Safety Notice

Technical Bulletin No. 019

No. 019	Target audience Affected users	Date 2020-04-09	Number of pages 5
Affected products Battery corpuls cpr P/N 09120	Serial numbers / Lot identification No relation	Software / Firmware Each firmware version up to and including 1.3-004

Illustration 1: Rating plate battery corpuls cpr - e.g. firmware version 1.2-002

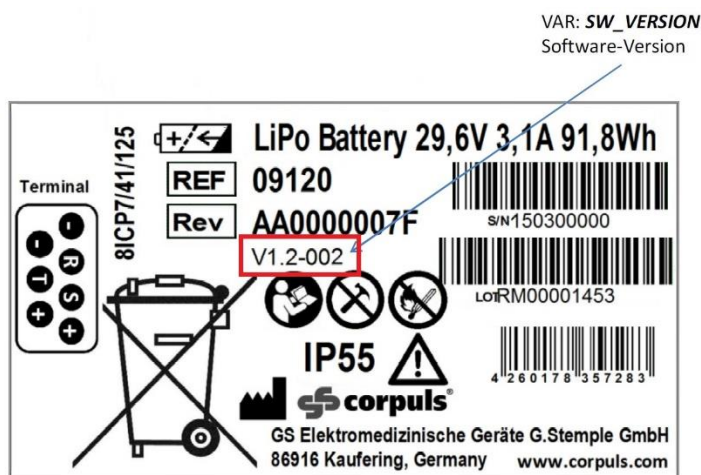
Your battery corpuls cpr has installed one of the firmware versions up to and including 1.3-004 that we have identified as problematic.

This can be seen on the rating plate of the battery corpuls cpr.

Maintenance for each battery will be promptly arranged. A new firmware version 1.4-000 or higher will be installed on your battery corpuls cpr by our authorised sales and service partners. So you will soon have a fully operational corpuls cpr.
